Docket Item # 12 BAR CASE # 2009-0175

ISSUE: Signage

APPLICANT: Candey's of Alexandria

LOCATION: 817 South Washington Street

Figure 1. Updated sign details for September 16th BAR hearing.

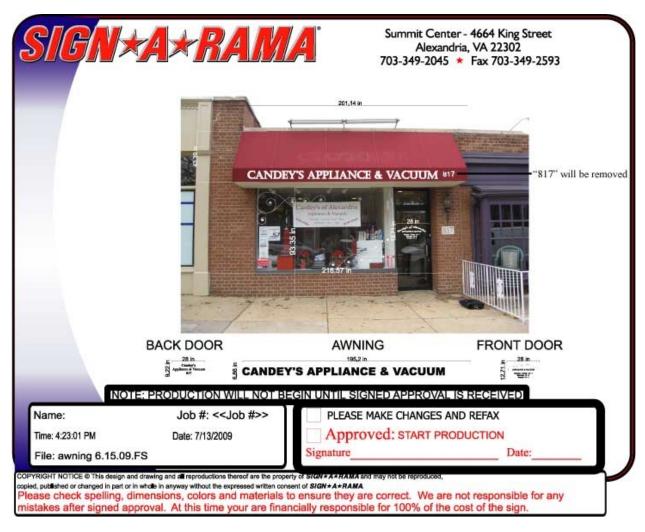
New lettering will be applied to the front valance of the maroon shed awning. The graphics applied on the front will include the name of the business, and will measure 16.27 feet by .57 feet. The signage on the ends of the awning has been deleted and the applicant has indicated that the address number, 817, will be removed from the awning.

Figure 3: Sign specifications – front door.

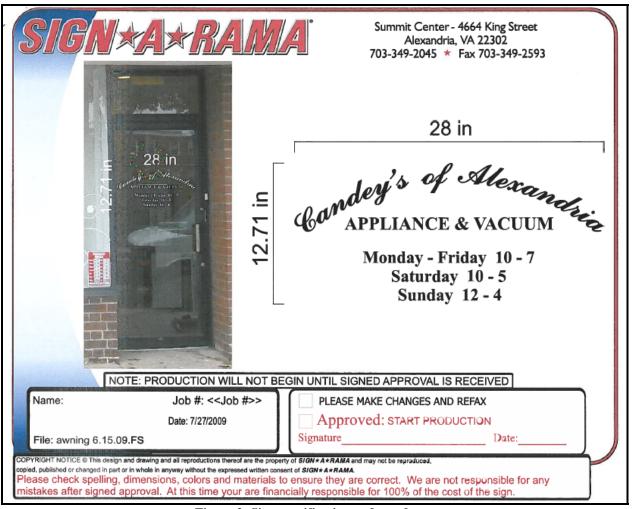
The applicant also proposes signs on the rear alley door and the front door. The back door graphics will identify the business and will measure 0.7 feet by 2.33 feet. The front door sign is proposed to read CANDEY'S OF ALEXANDRIA APPLIANCE AND VACUUM and will include the hours of operation (measuring 2.47 square feet). The applicant did not submit revised drawings for the sign on the front door but has indicated a willingness to change the font of the CANDEY'S OF ALEXANDRIA portion of the sign to match the font on the awning.

- 1. That the font of the CANDEY'S OF ALEXANDRIA on the door sign match the font on the awning sign; and,
- 2. That the sign with a phone number in the storefront window be removed, along with the Miele and Viking signs which are considered "special advertising."
